SITE PLAN REVIEW AND APPEARANCE BOARD

File No: 2020-054-SPM-SPR-CLIV

Application Name: The Ray Hotel

The action before the Board is for the approval of a Class IV Site Plan application for The Ray Hotel pursuant to LDR section 2.4.5 (F)(1)(a), including the following:

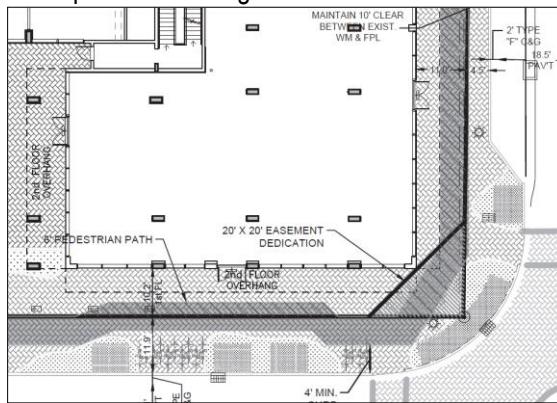
***As a result of the proposed Lot split The Ray Hotel will now have a 35'-1³/₄" side interior setback for the Esplanade Plaza/proposed The Ray House parcel to the north.

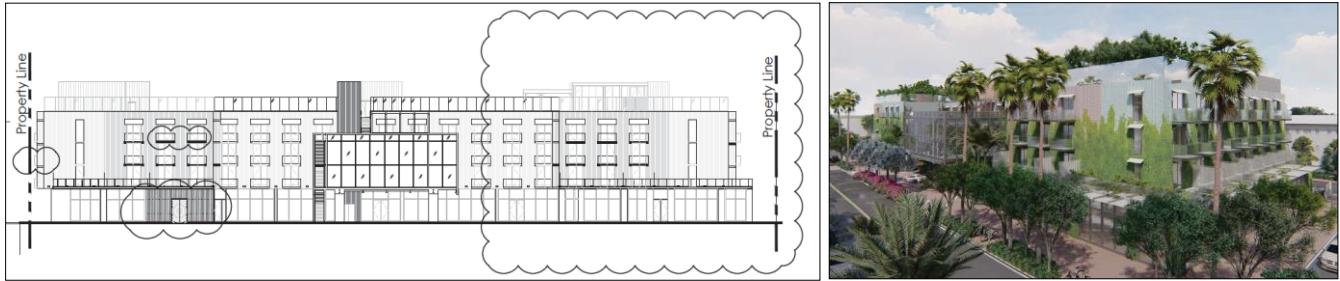
- The LDR requires that all buildings in the CBD have a Tripartite Composition (base, middle, and top). The proposal uses a highly transparent storefront as the base, with the corrugated metal body comprising the middle (the second, third, and fourth stories above the storefront base). The elevation plan shows the base of the building with storefront windows with aluminum framing. The storefront system on the base of the building is augmented by wood paneling, exposed concrete columns, and potted plants that provide unique contrasts. The middle of the building is composed of floors 2, 3, and 4 and has a façade composed of corrugated metal panels, fabric awnings, and glass glazing with aluminum framing. The top of the building includes a rooftop terrace with a restaurant structure, pool, trellis stairwells, and elevator shafts. The top of the building includes changes in color, materials, and uses. The LDRs require flat roofs to be screened from view by a parapet; this design proposes to use a transparent wall.

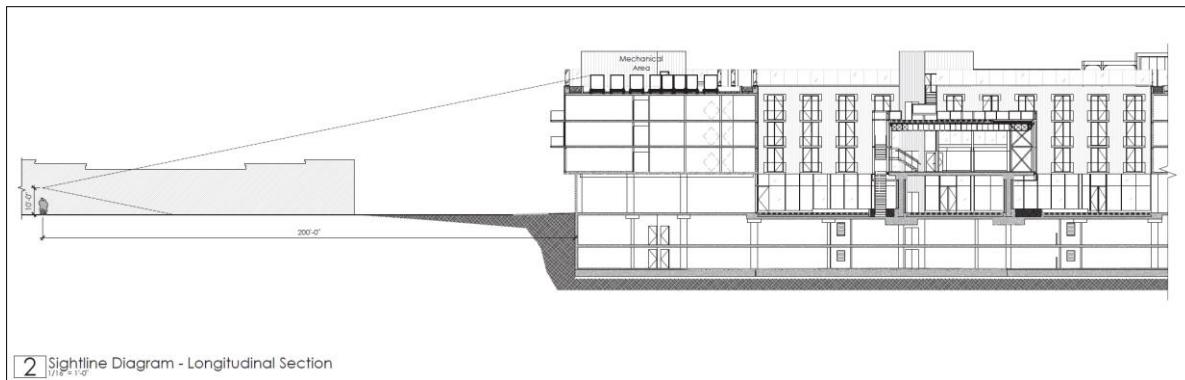
- The site plans show that a Plaza type civic open space is being proposed. Pursuant to LDR Section 4.4.13 (G)(2)(b), "A plaza is at least 1,500 square feet in size and adjoins streets on at least two sides or a street and a pedestrian passageway or main building entry. Plazas are mostly hardscaped with formally arranged landscaping and a water feature." In accordance with the LDR the civic open space is required to be 1,660 sq. ft. ($20,000 * 0\% = 0$, $+ 20,000 * 5\% = 1,000$ sq. ft., $+ 7,334$ sq. ft. * 9% = **660** sq. ft.). Sheet 25 shows a 4,098 sf plaza open space provided on the west side of the building, which exceeds the minimum requirement of the LDR. The plaza design shows paving, benches, one drinking fountain, trash receptacles, a pet clean up station, and patio space. The design also shows a portion of the civic open space with outdoor dining seating which is allowed in accordance with LDR Section 4.4.13 (G)(4)(a).

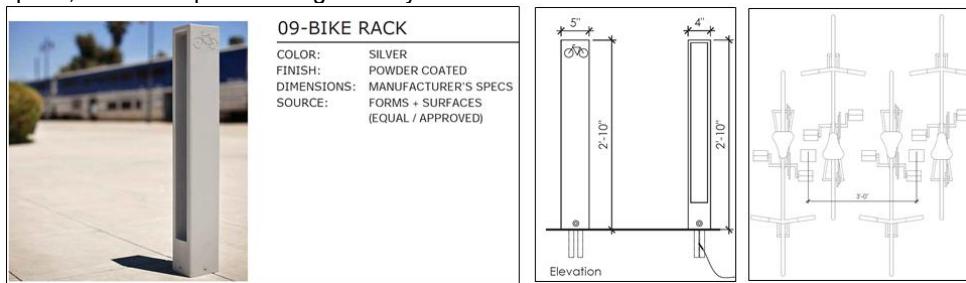
- Per the aforementioned LDR section, the subject site is required to provide 18 bicycle parking spaces. The site plan provided shows 12 dual space bicycle parking racks (24 spaces). The bicycle spaces would be accessible by both The Ray and The Ray House sites. The LDR states “if more than 10 spaces are required, then 50% shall be in lockers or secured, inside the storage area.” The previous CLIV site plan application (2017-197) approved the bicycle parking racks in central and public ROW locations, and not in lockers or secured storage locations. The plans show the bicycle racks to be located within the public ROW, civic open space, and linear pedestrian greenway.
